CALL NO. 101  
CONTRACT ID NO. 111313  
ADDENDUM # 1

Subject: Jefferson County, HPP 0163 (032)  
Letting April 22, 2011

**The Parklands of Floyds Fork - Project 2A**  
 Backley Creek Park - North  
 Louisville, Kentucky

MODIFICATIONS TO CONTRACT DOCUMENTS:

Drawing Title:  
**WALL 2  
LAYOUT &  
DETAILS**  
Drawing No:  
**SW-2001**

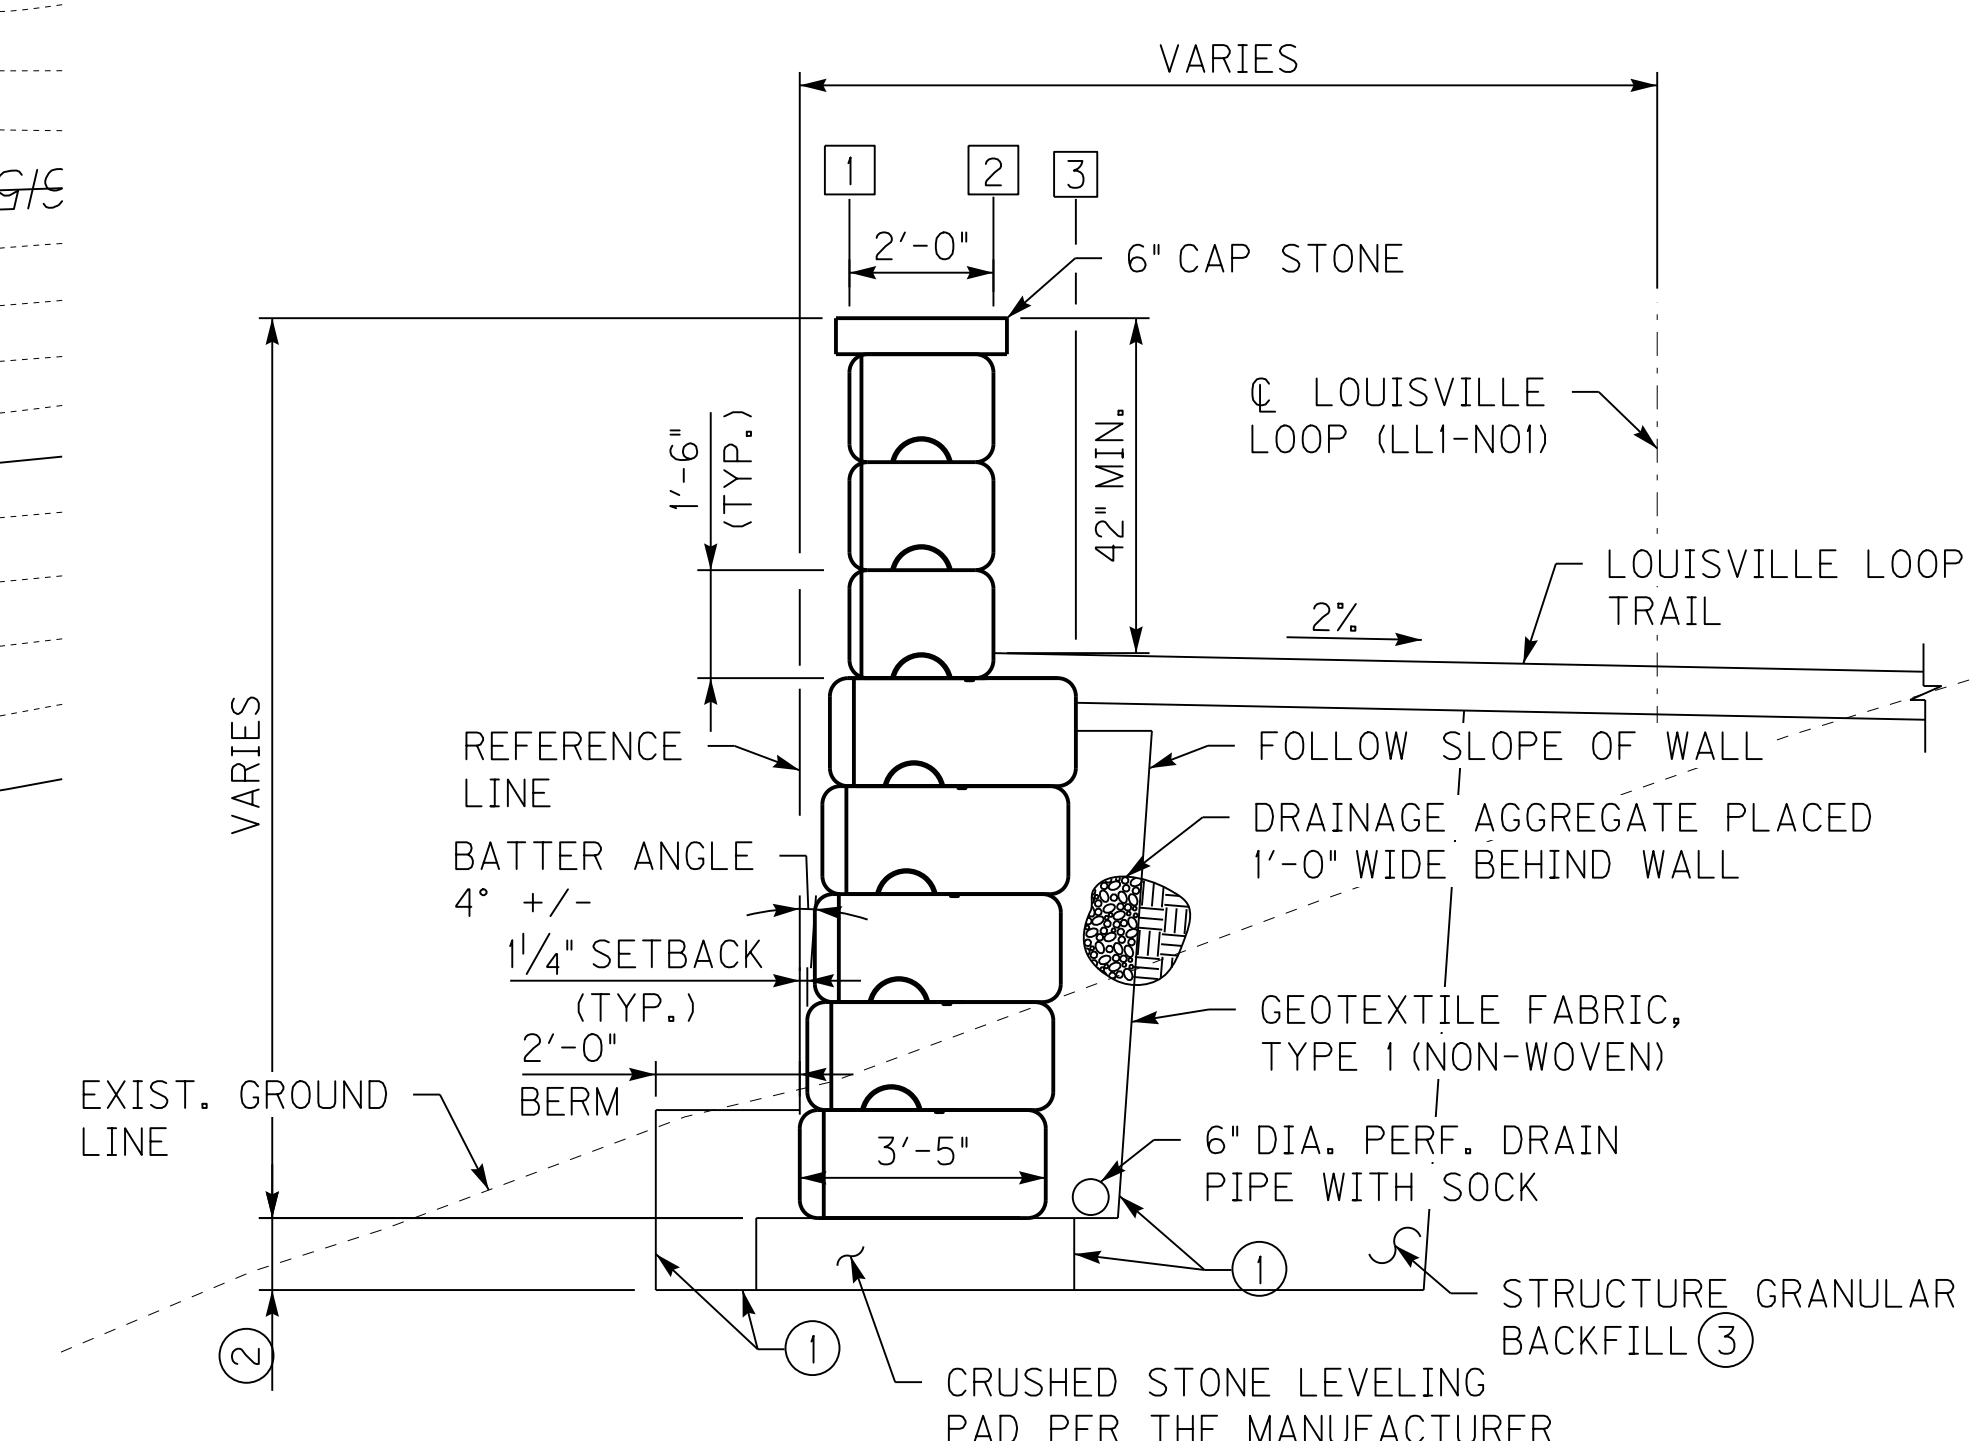
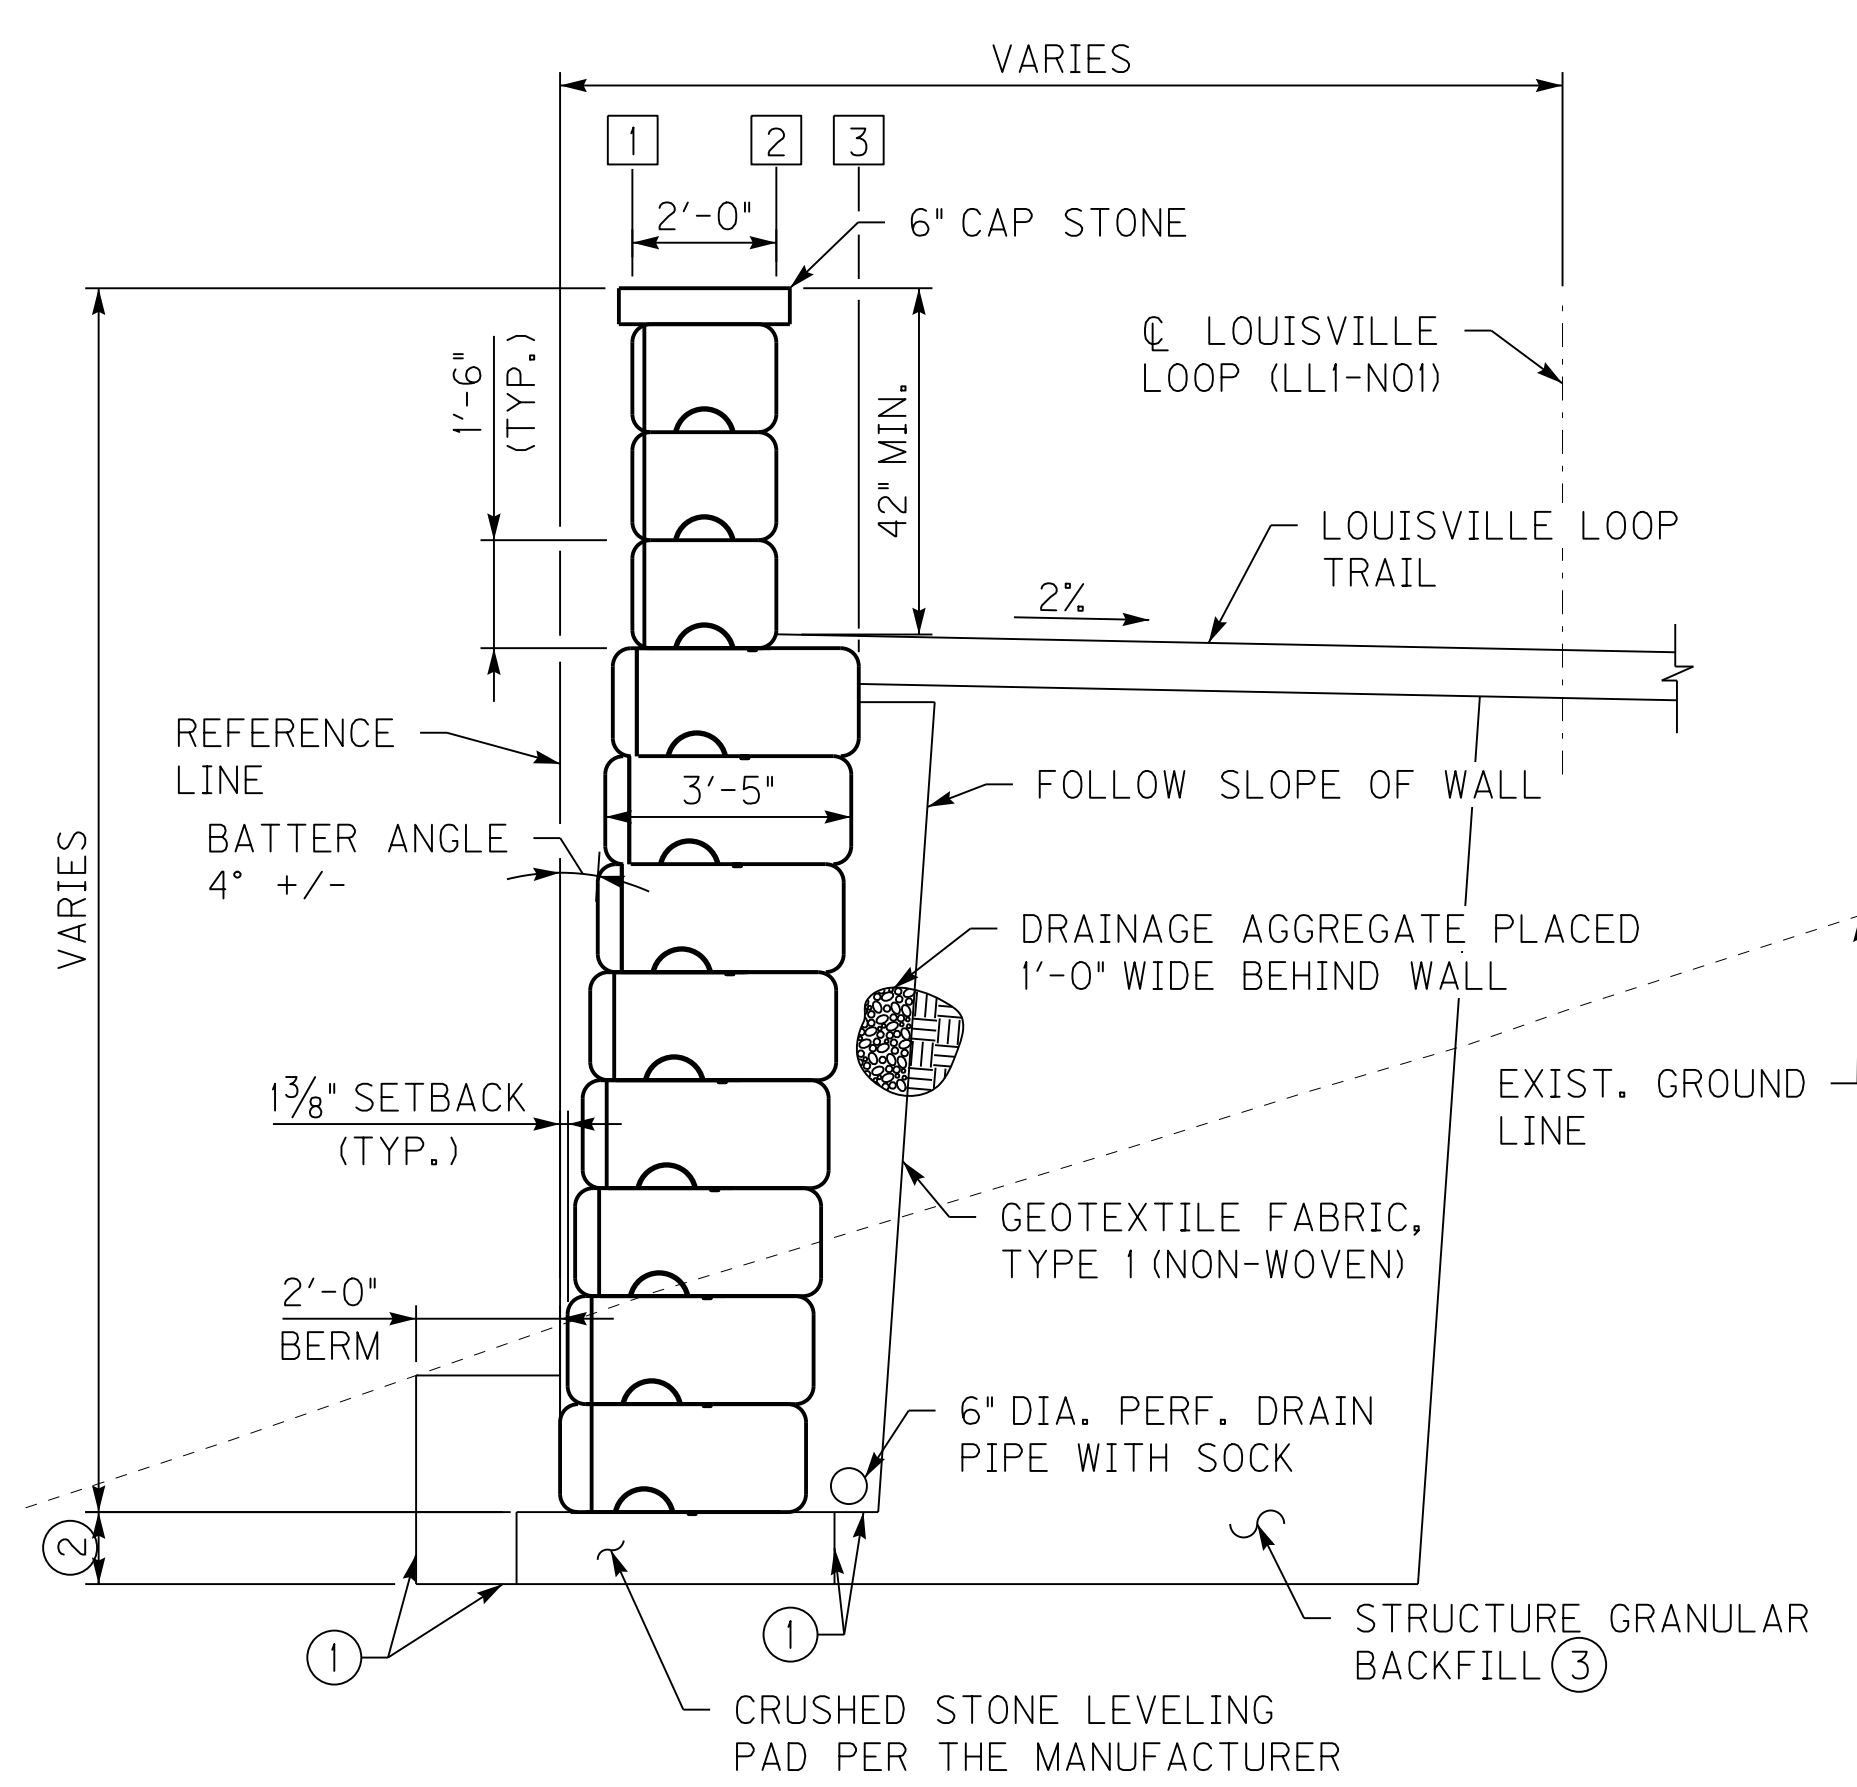
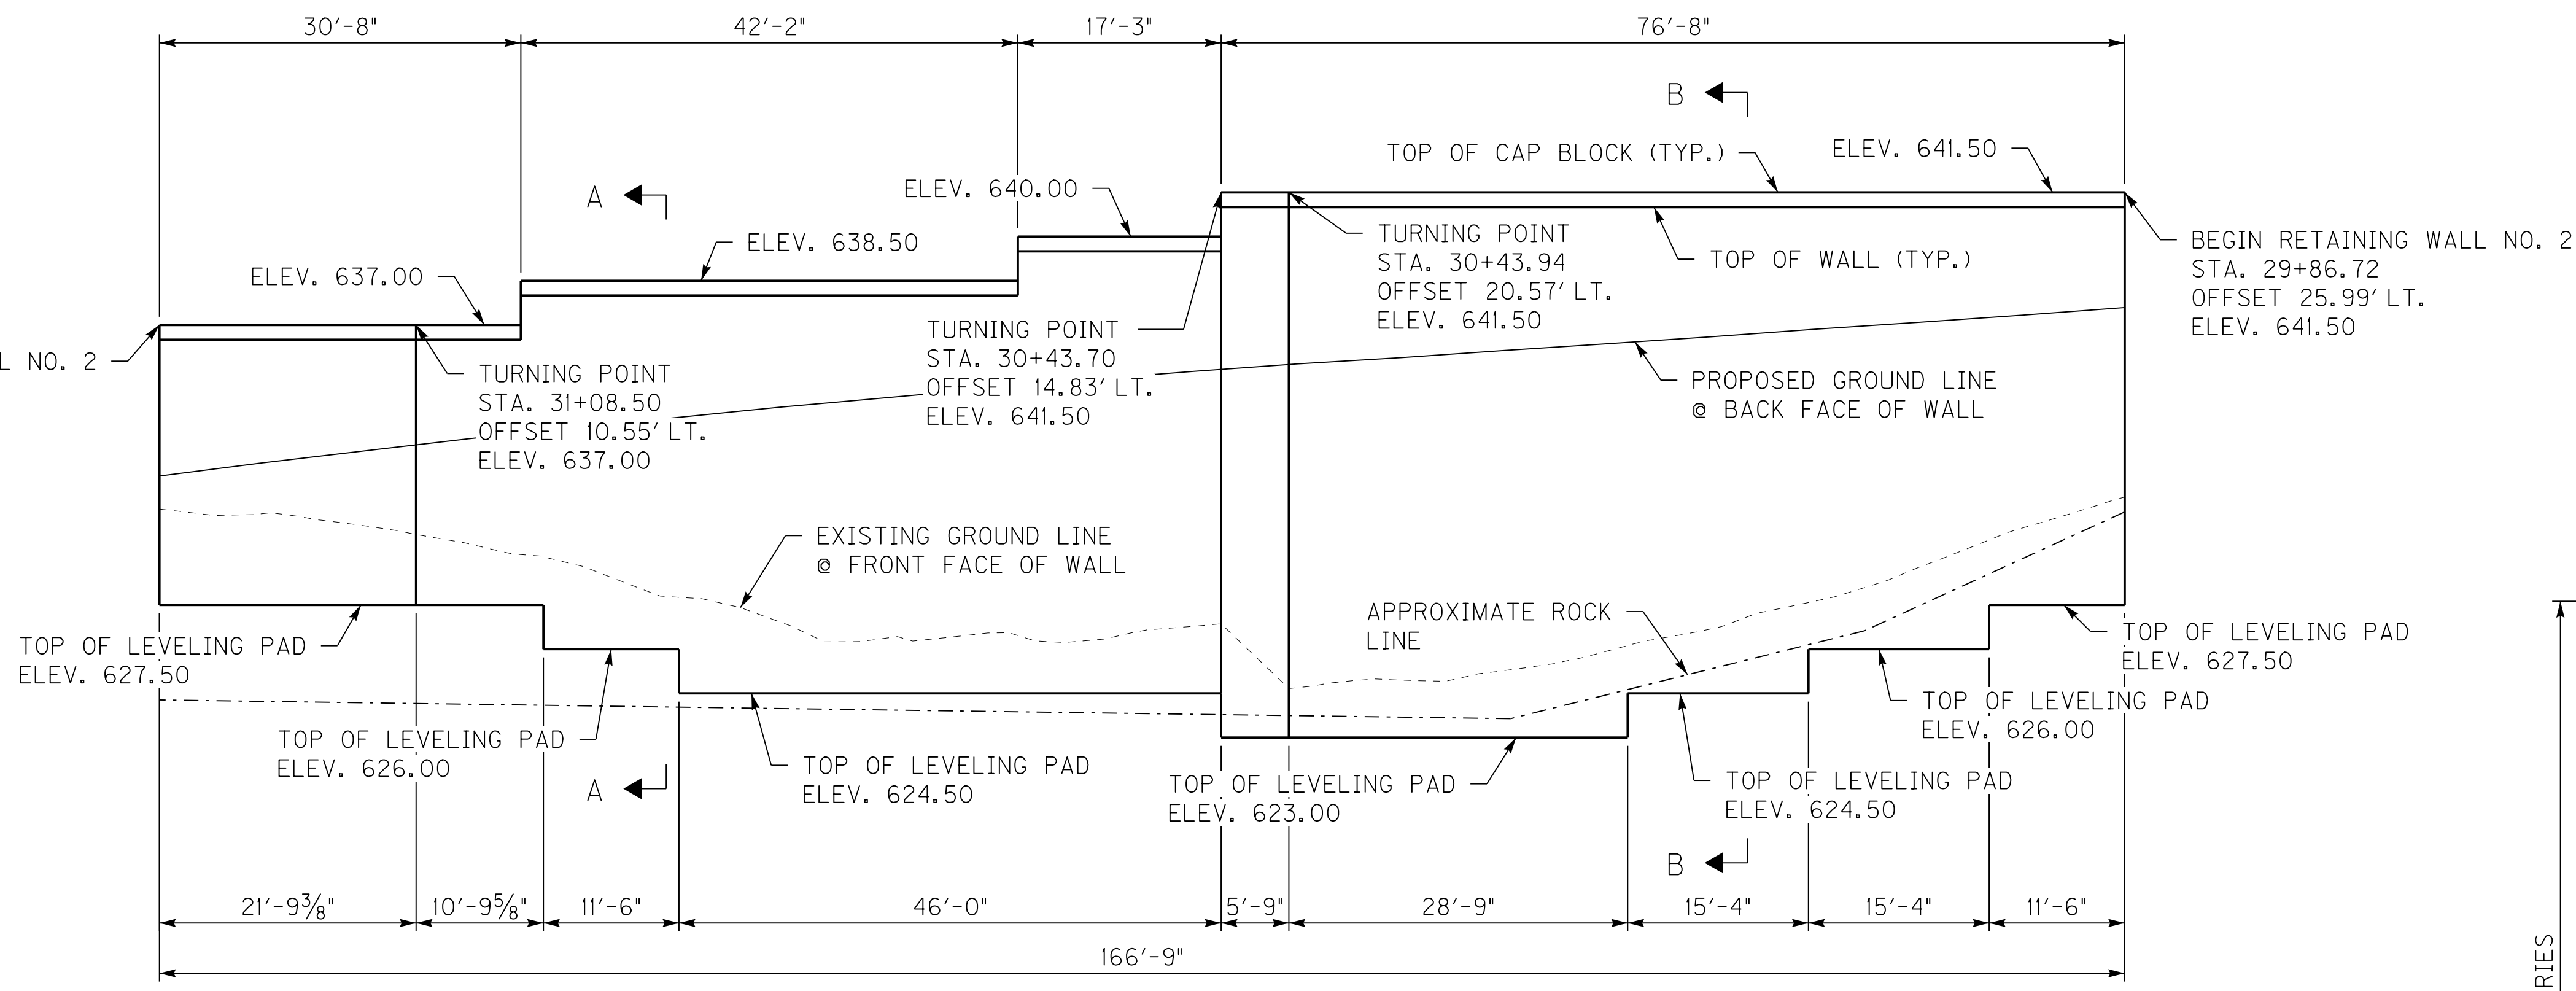
- SW-1001 Revised note to read “The wall block system shall be the Ledgestone series with color scheme “Kentuckiana Buff” as manufactured by Redi-Rock of Kentuckiana, Mt. Washington, KY., or approved equal.
- SW-2001 Revised note to read “The wall block system shall be the Ledgestone series with color scheme “Kentuckiana Buff” as manufactured by Redi-Rock of Kentuckiana, Mt. Washington, KY., or approved equal.
- SW-3001 Revised note to read “The wall block system shall be the Ledgestone series with color scheme “Kentuckiana Buff” as manufactured by Redi-Rock of Kentuckiana, Mt. Washington, KY., or approved equal.
- SW-6001 Revised note to read “The wall block system shall be the Ledgestone series with color scheme “Kentuckiana Buff” as manufactured by Redi-Rock of Kentuckiana, Mt. Washington, KY., or approved equal.
